UNITED STATES PATENT AND TRADEMARK OFFICE

Office Action Summary

10/809,138

GARNETT, PAUL JEFFREY

Figures 6 and 7 of US Patent Number 5,490,452 (Schlosser et al. hereinafter)

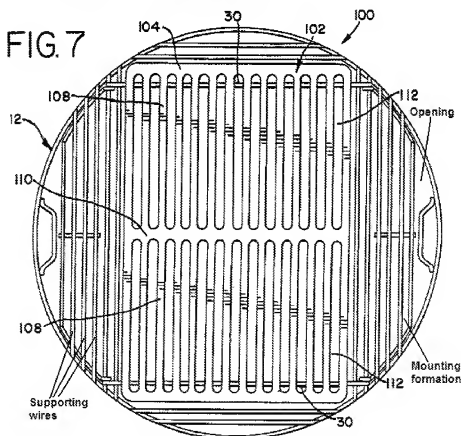
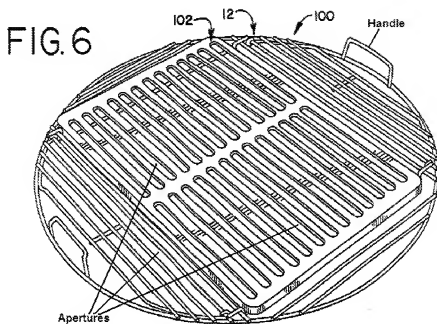
8. In re claim 1 Schlosser et al. discloses an apparatus comprising:

wherein the substantially planar portion of the grill (100) comprises an opening capable of receiving a handle of a substantially similar grill (100) when two or more substantially similar grills are stacked, apart from their respective fan housings, such that the substantially planar portions of the stacked grills (100) are substantially parallel when the grills (100) are stacked;

11. In re claim 4, Schlosser et al. discloses the grill of Claim 1, wherein said substantially planar portion comprises at least one shaped wire arranged to form a loop (12) or partial loop.

Figure 2 of Bull et al.

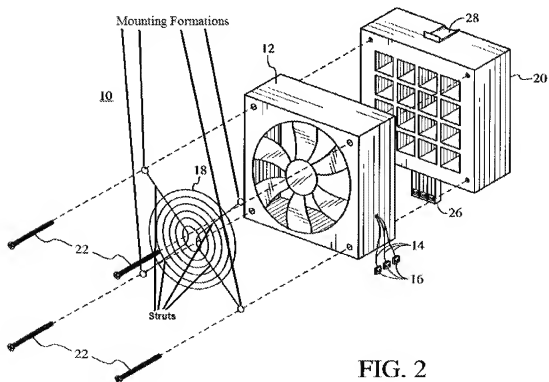
22. Bull et al. teaches a fan grill (18) comprising a substantially planar portion comprising a plurality of said loops or partial loops.

23. It would have been obvious to one having ordinary skill in the art at the time the invention was made to modify Schlosser et al. to include a plurality of said loops or partial loops as taught in Bull et al. with the apparatus disclosed by Schlosser et al. for the purposes of adding structural rigidity.
